Rezoning Application:

PD 24-0791

Development Services Department

1.0 APPLICATION SUMMARY

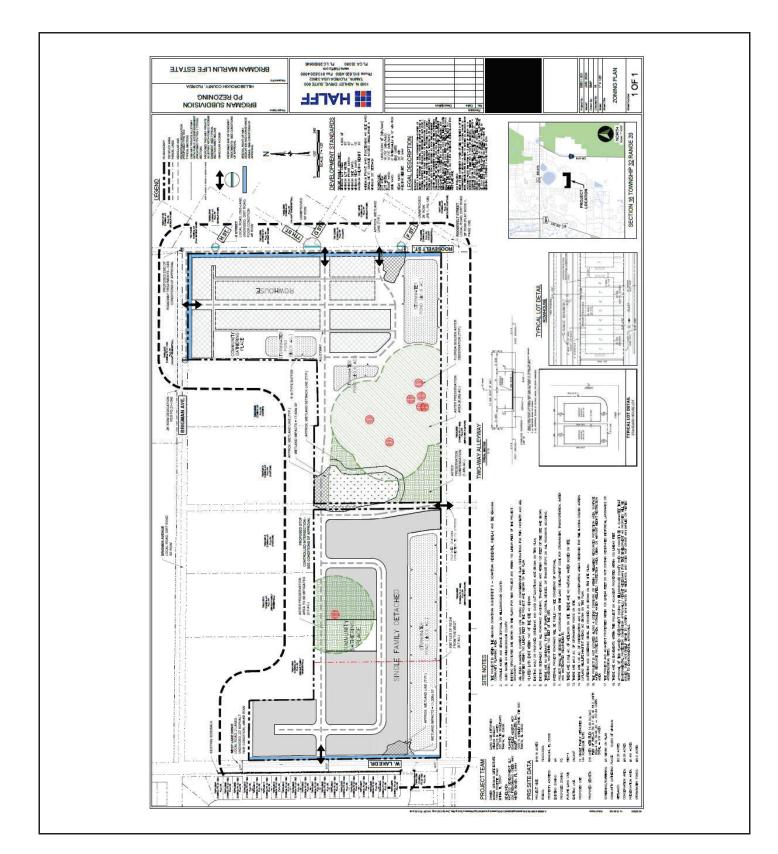
Prior to Site Plan Certification the following shall be amended:

- Revise Site Plan Development "Rowhouse Typical Lot Layout" to change the proposed front setback from a minimum of 2-feet to minimum of 10 feet Lot Min. Front Setback.

- Revise "Typical Lot Detail" showing a 50' x 100' lot minimum equaling a 5,000-sf lot. Revise proposed lot dimensions for "Typical Lot Detail" minimums to align with the proposed 4,800-sf min. lot area in the Development Standards table.

- Revise Minimum Rowhouse: Front Yard in Development Standards from "10'/15' (Min./Max.)" to 2'/15' (Min. / Max.).
- Revise Typical Lot Detail for Rowhouse to "7.5' min. / 10' max." for each End Unit equating to between 15' and 20' between two end units. Delete "0' Min. / 10'" Typical Lot for End Unit as end units cannot be 0'.

- Revise note 10 to instead state, "Alleyways will be privately maintained with public access easements. Roadways may be public or privately maintained. If private, roadways will be publicly accessible (i.e. have public access easements). Internal roadways shall comply with Policy 4.1.4 of the Hillsborough County Mobility Element, which will be determined at the time of plat/site/construction plan review."

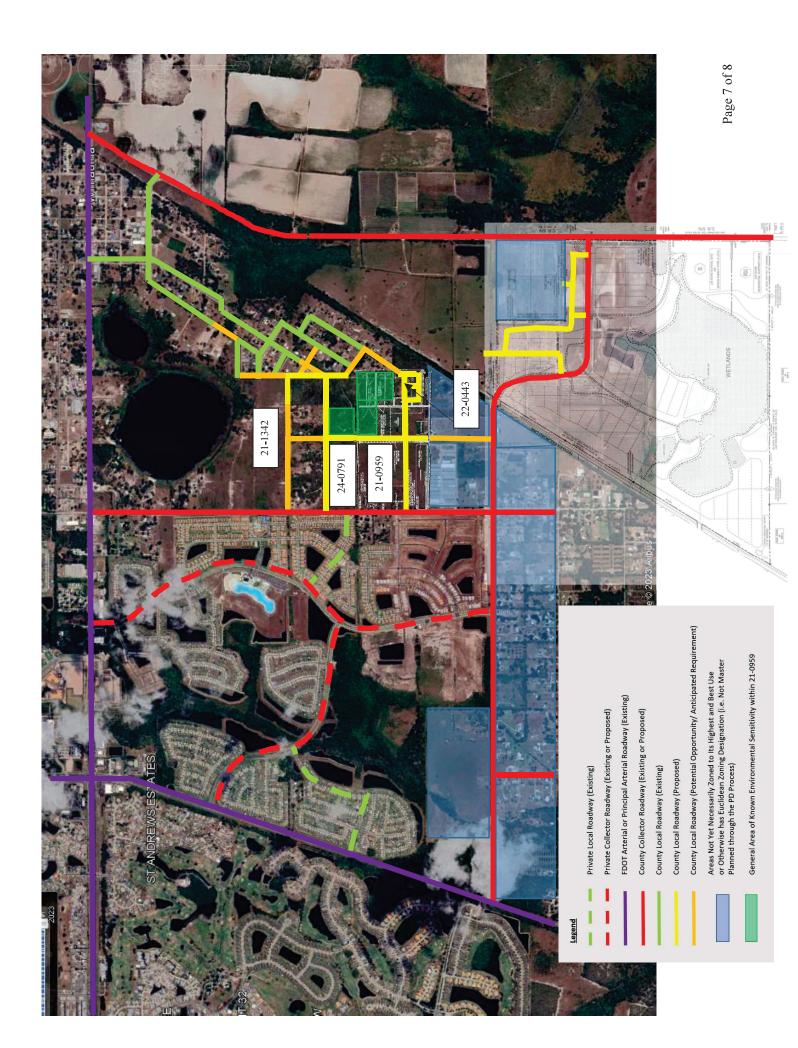
Staff notes that 25-feet of the necessary right-way necessary to construct Brigman Ave. is being dedicated by the School District of Hillsborough County, in accordance with PD 21-1342 zoning condition 24. The developer of the subject PD will be required to dedicate any additional right-of-way necessary to ensure 50-feet is available for the construction of the required Brigman Ave. segment along the northern PD boundary. Similarly, the developer will be required to dedicate any additional right-of-way needed as necessary to construct Roosevelt St. along the eastern boundary.

Staff has included a rough and ready graphic, below, to demonstrate how the proposed development interfaces with existing and planned roadways in the vicinity of the project. Staff has overlaid certain PD site plans from surrounding projects on an aerial, all of which have been approved.

FIGURE 1

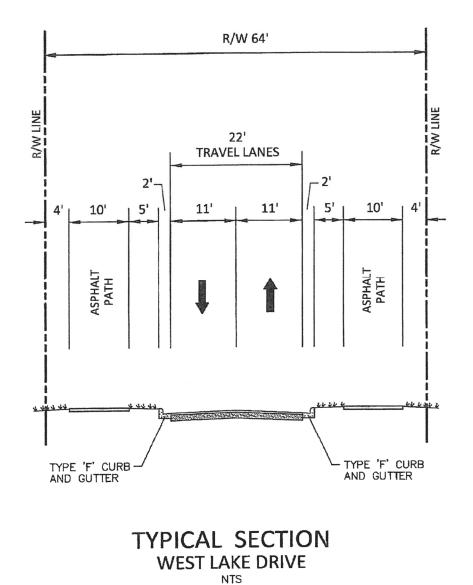
The Development Agreement provides two alternative sections. The first is where there is sufficient right of way to provide the proposed section which is shown in Figure 1. Figure 2 illustrates the proposed section where right of way is limited and/or there are design constraints. The primary difference in these sections is the distance from the back of the curb to the sidewalk. It should be noted that the distance between the back of the curb and sidewalk can vary depending on the right of way and roadway constraints. This section will be minimized to the greatest extent feasible. The sections include the following:

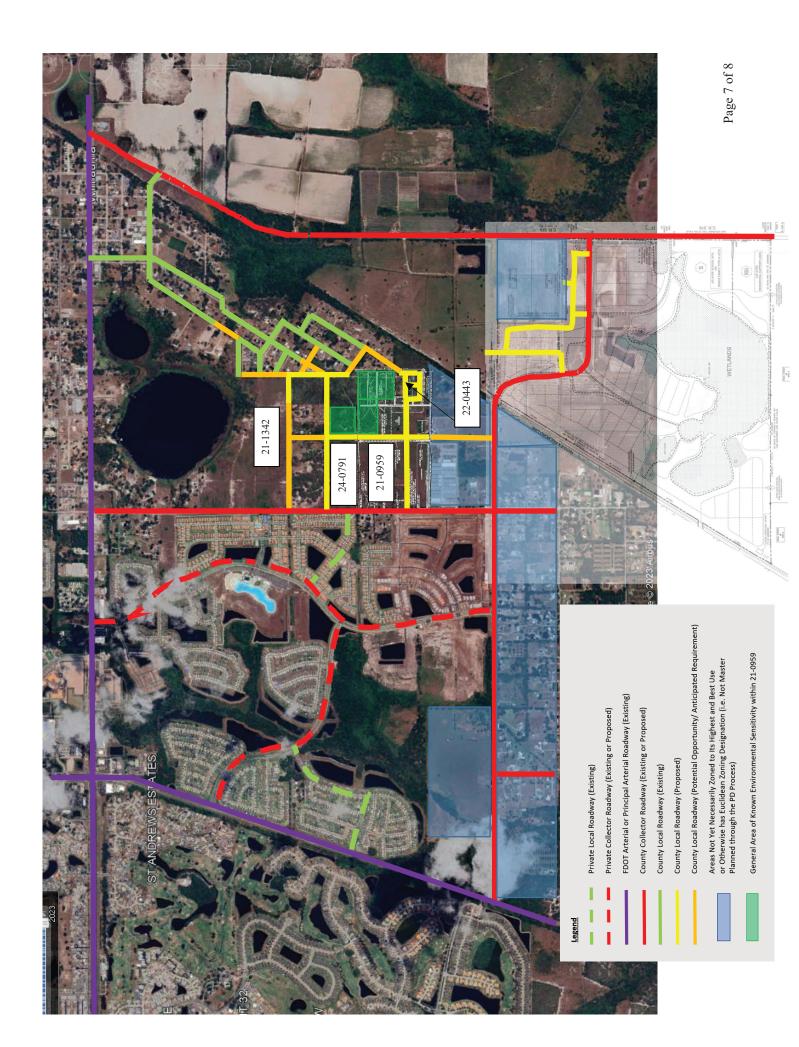
Staff notes that 25-feet of the necessary right-way necessary to construct Brigman Ave. is being dedicated by the School District of Hillsborough County, in accordance with PD 21-1342 zoning condition 24. The developer of the subject PD will be required to dedicate any additional right-of-way necessary to ensure 50-feet is available for the construction of the required Brigman Ave. segment along the northern PD boundary. Similarly, the developer will be required to dedicate any additional right-of-way needed as necessary to construct Roosevelt St. along the eastern boundary.

Staff has included a rough and ready graphic, below, to demonstrate how the proposed development interfaces with existing and planned roadways in the vicinity of the project. Staff has overlaid certain PD site plans from surrounding projects on an aerial, all of which have been approved.
